**October 3, 2024**

**Addendum No.:** 3

**Bid#:** 24-43-2

**Project Name:** Brewster Road Sewer Consolidation

SHEET NO.  
10PP-09

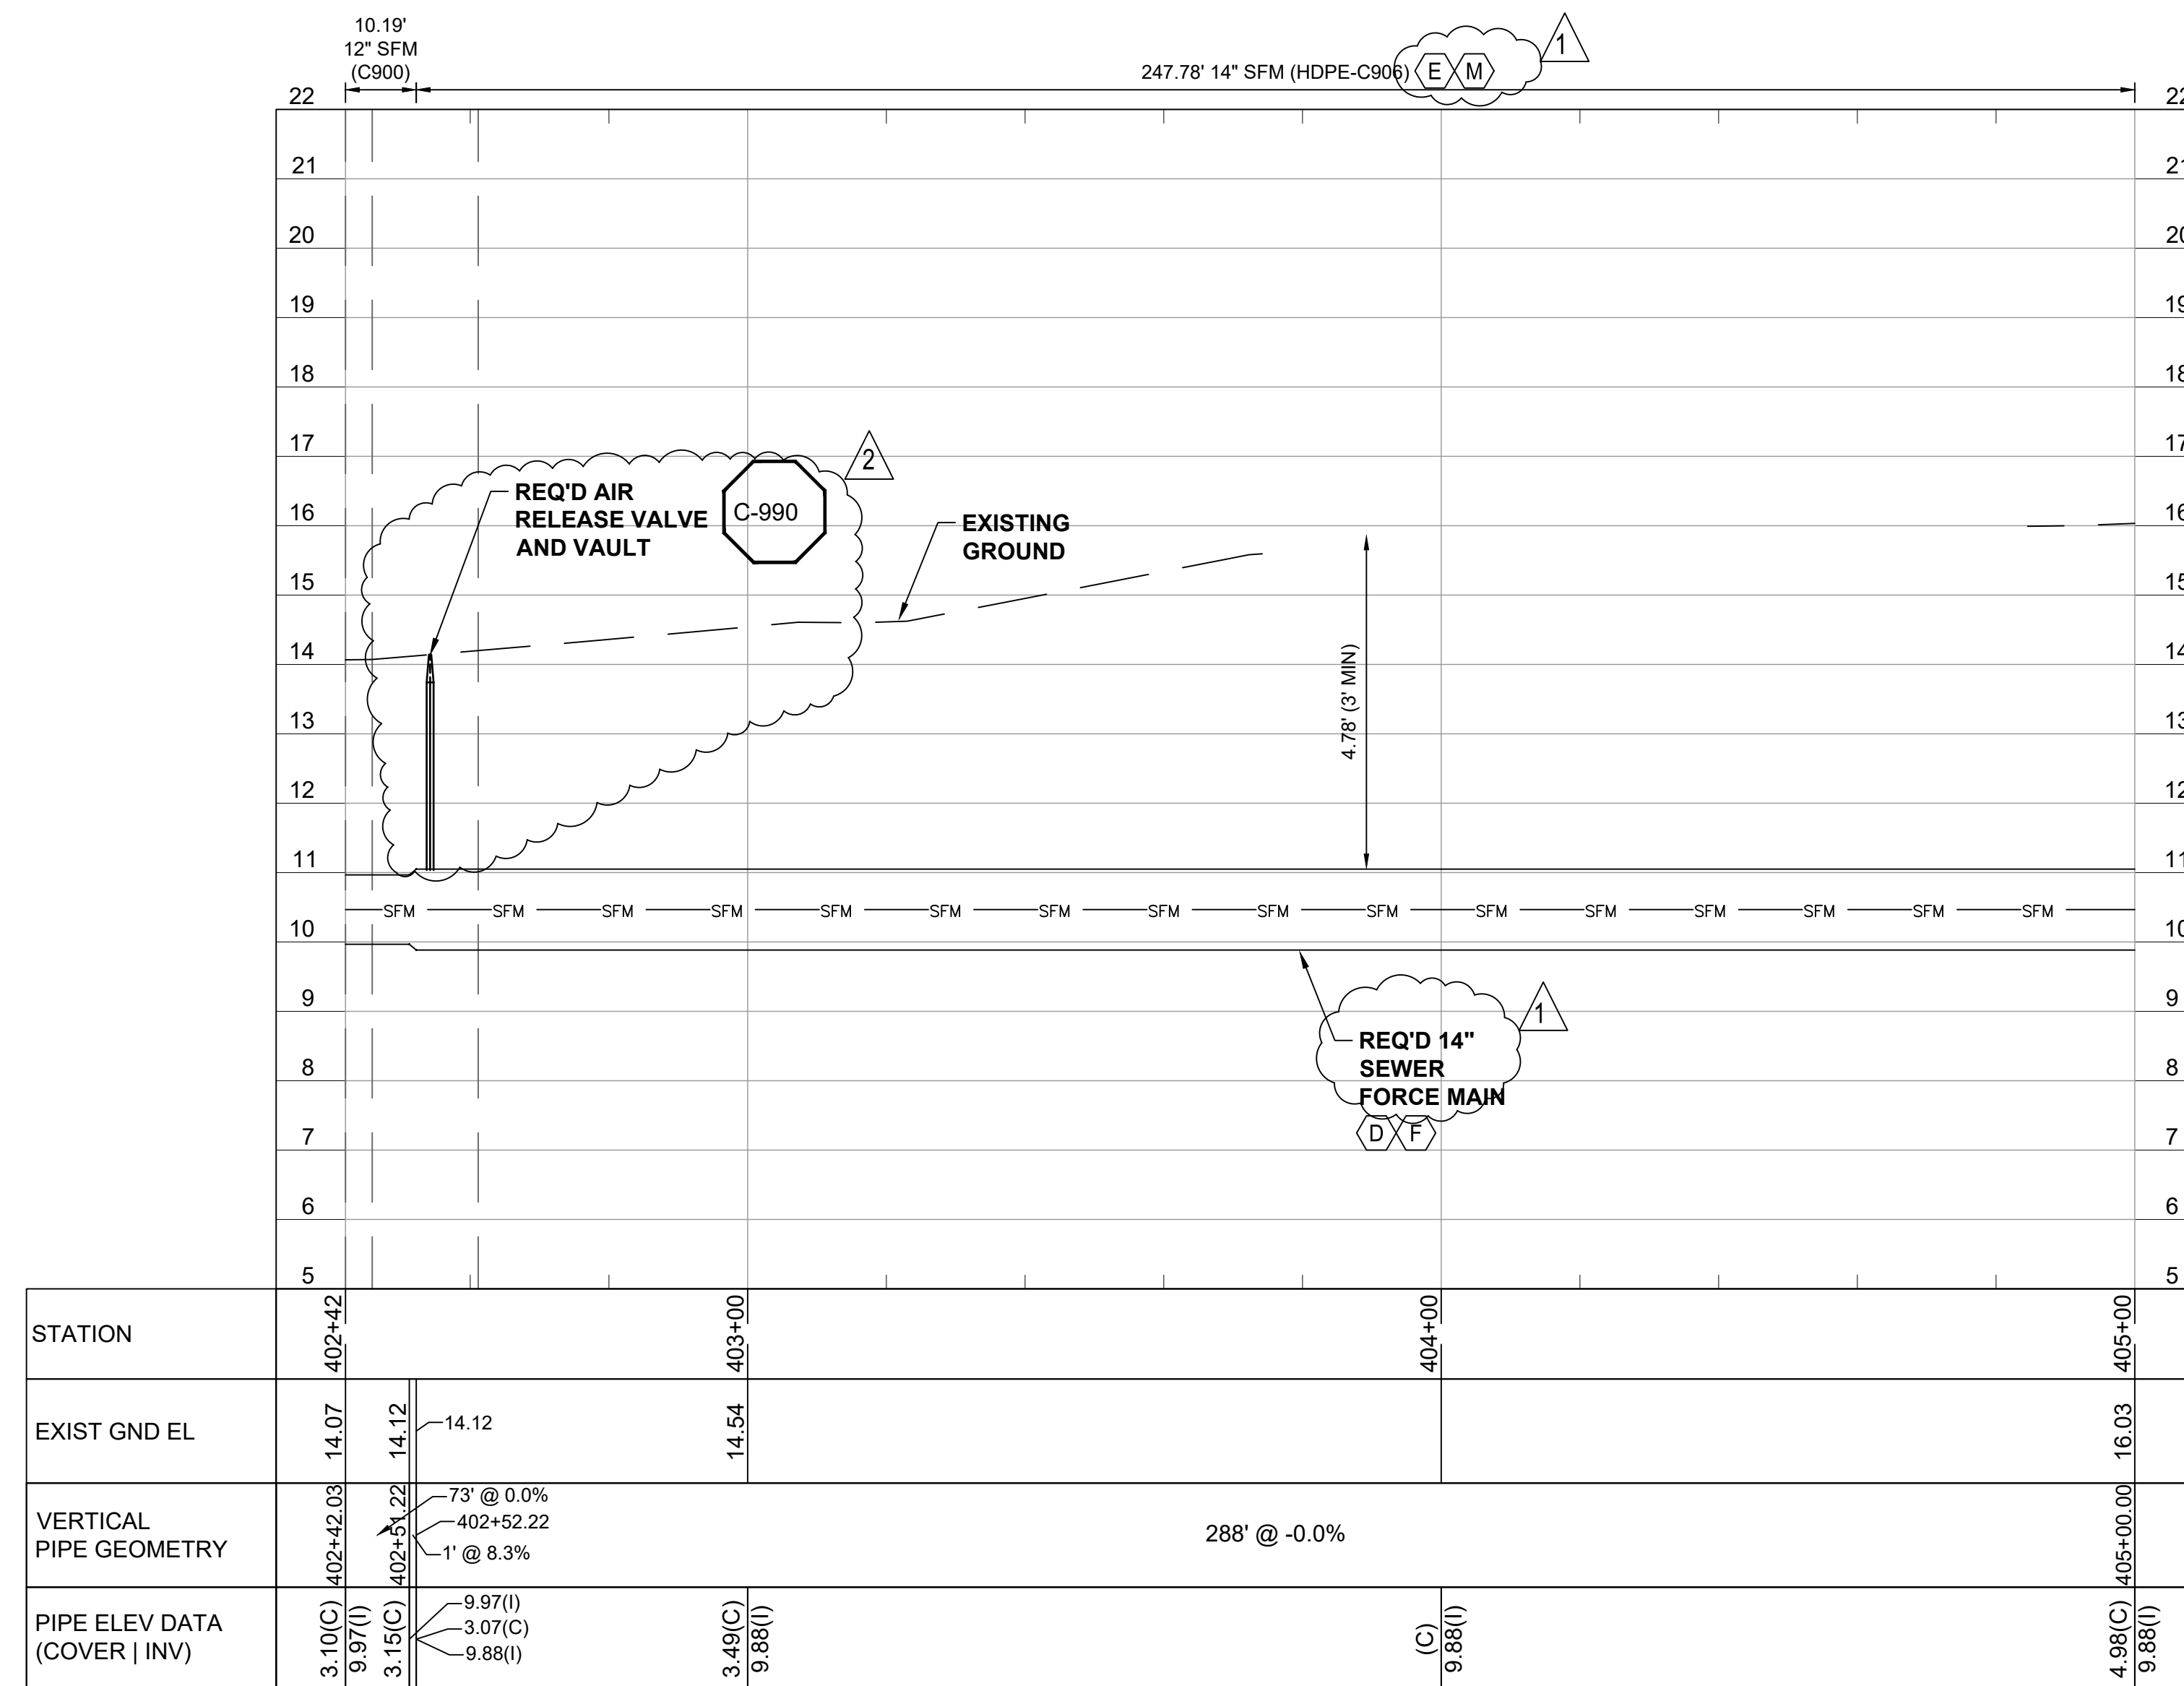
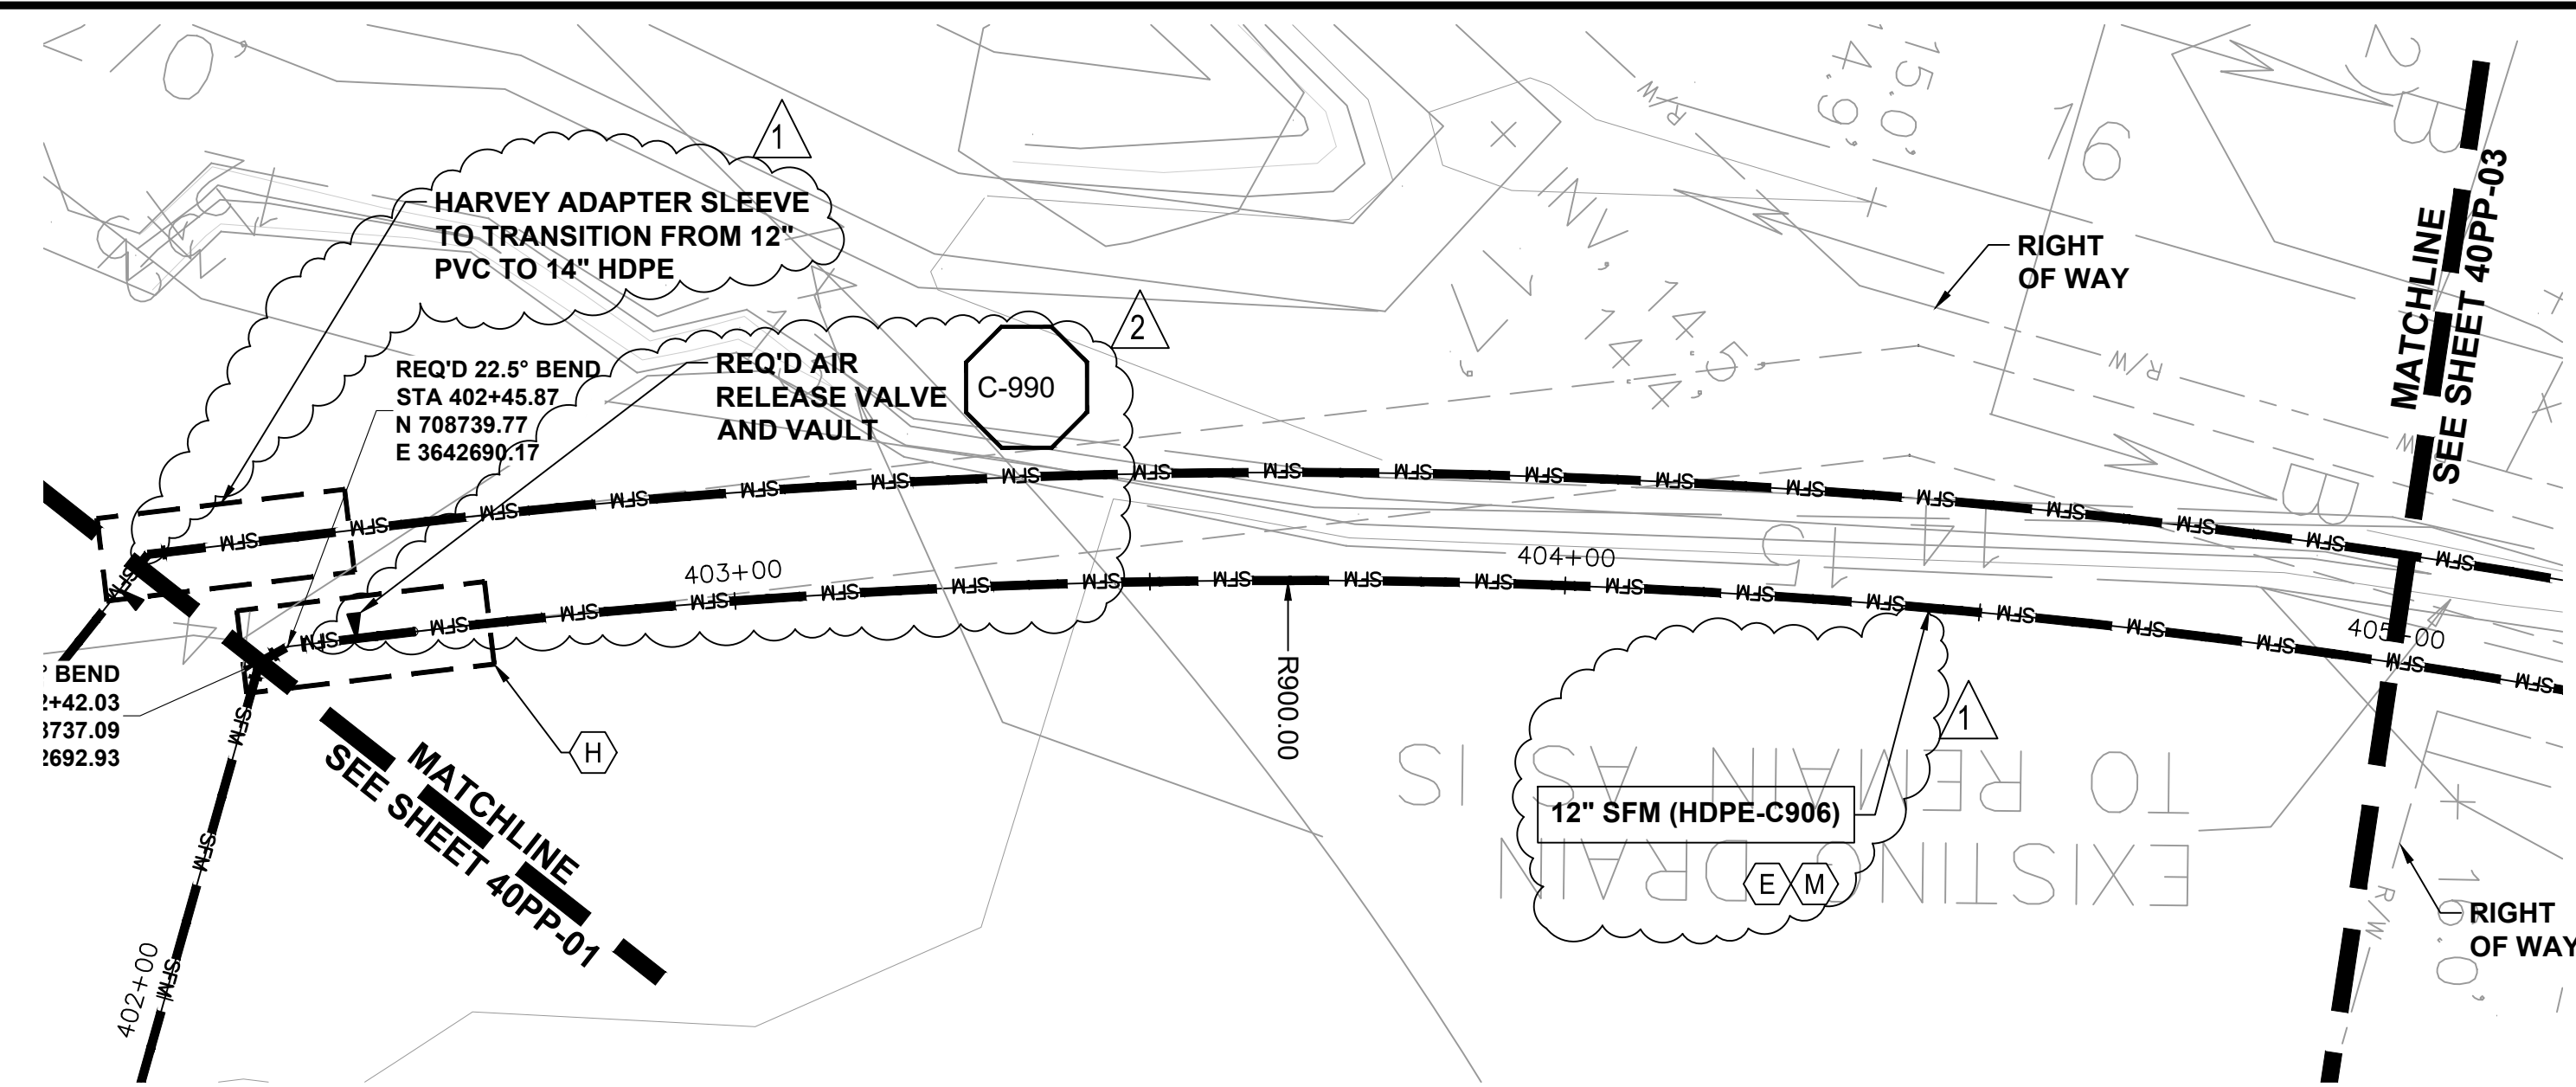
- b. DELETE previously issued drawing 10PP-09 and REPLACE with the attached REVISED Drawing 10PP-09.
- c. DELETE previously issued drawing 20PP-03 and REPLACE with the attached REVISED drawing 20PP-03.
- d. DELETE previously issued drawing 40PP-02 and REPLACE with the attached REVISED drawing 40PP-02.
- e. DELETE previously issued drawing 40PP-03 and REPLACE with the attached REVISED drawing 40PP-03.

SHEET NO.  
40PP-08

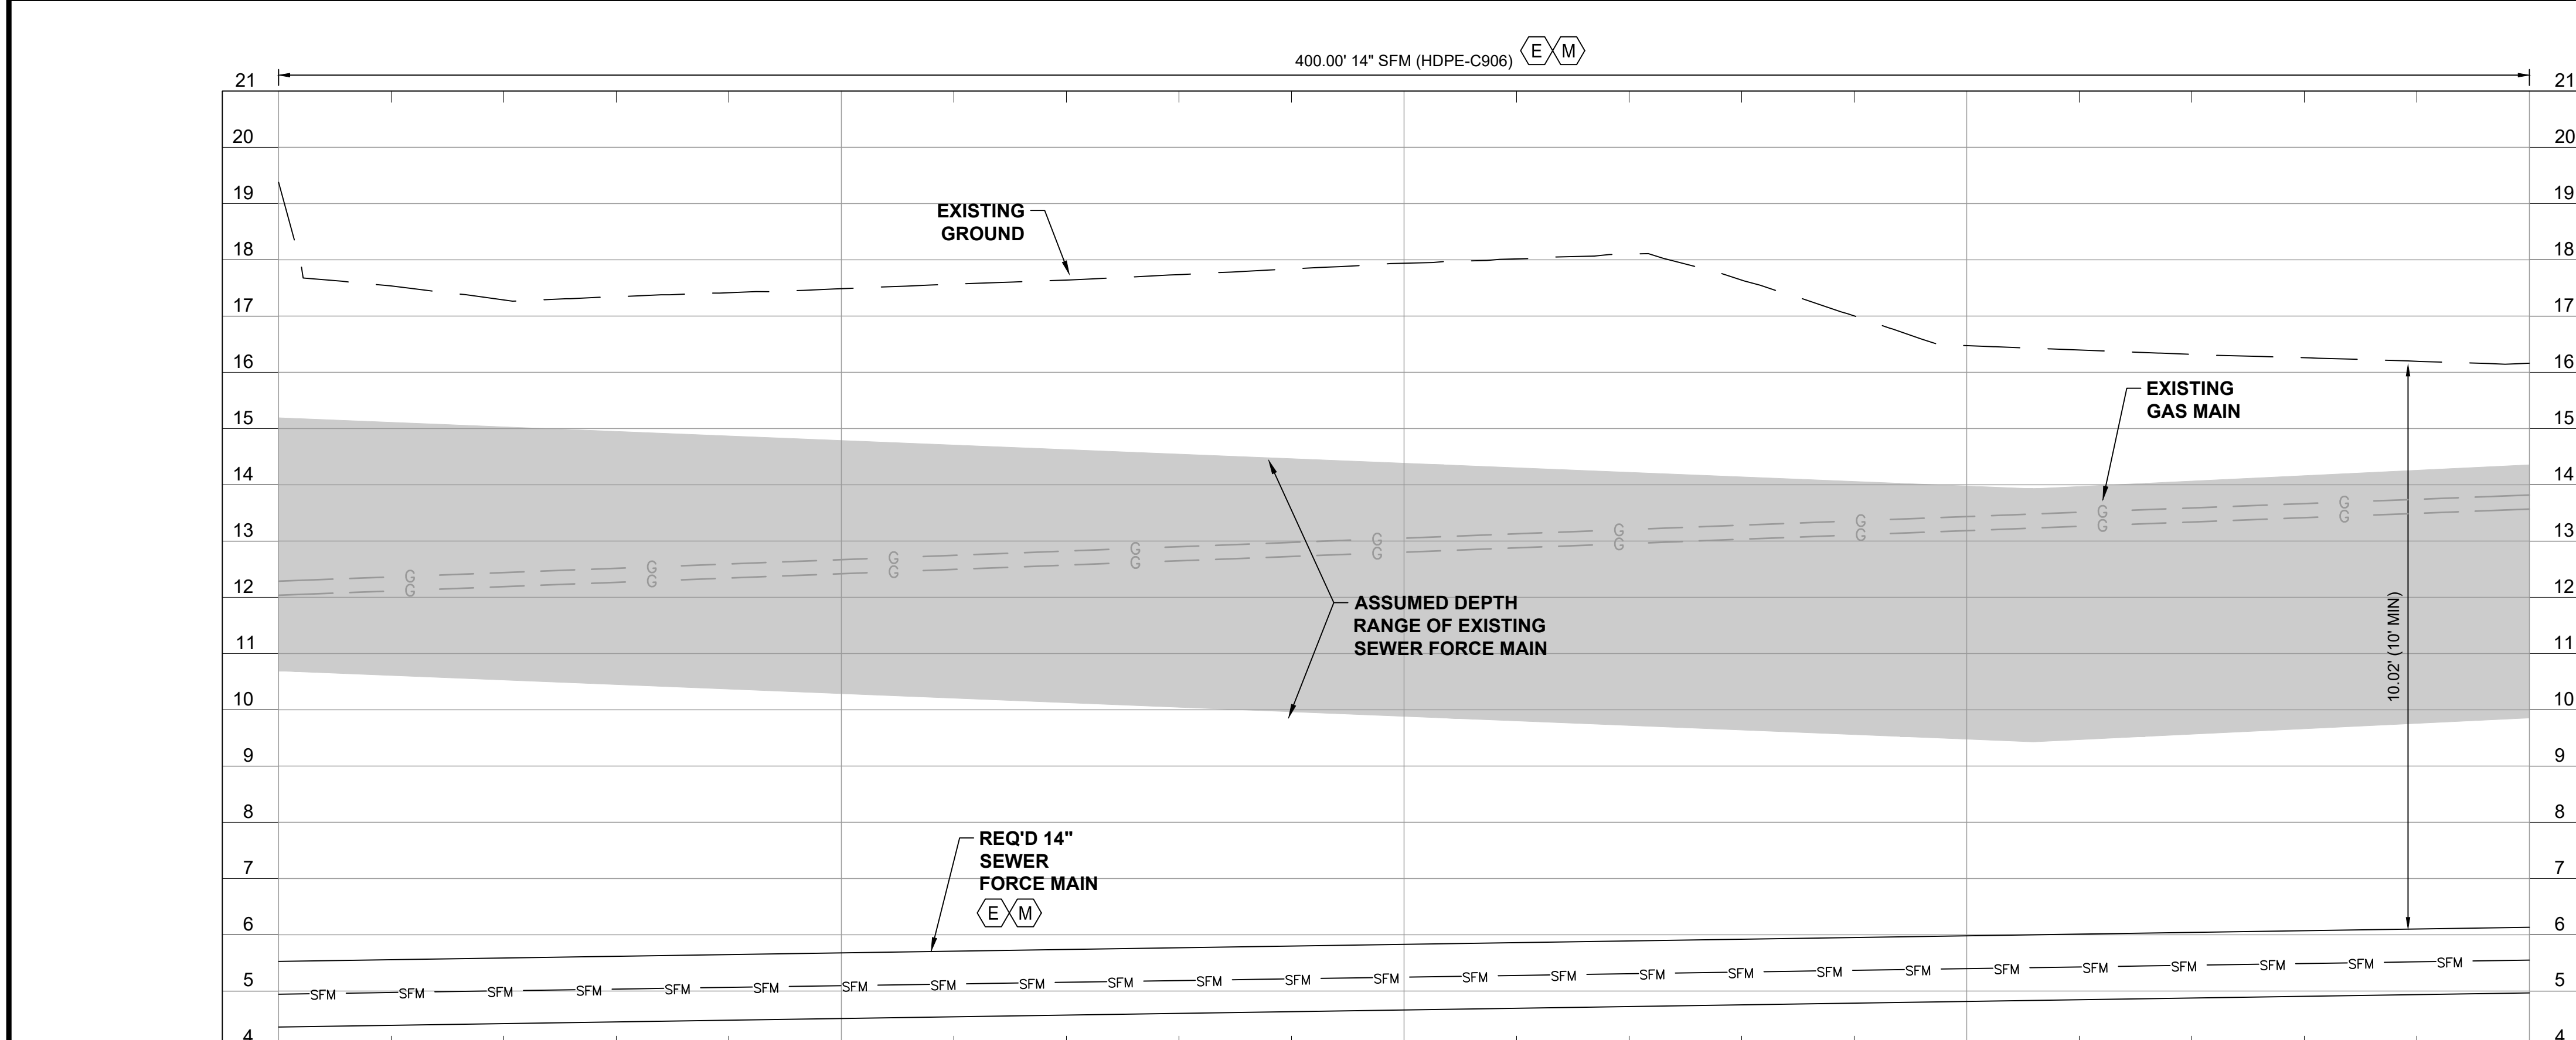
- f. DELETE previously issued drawing 40PP-08 and REPLACE with the attached REVISED drawing 40PP-08.
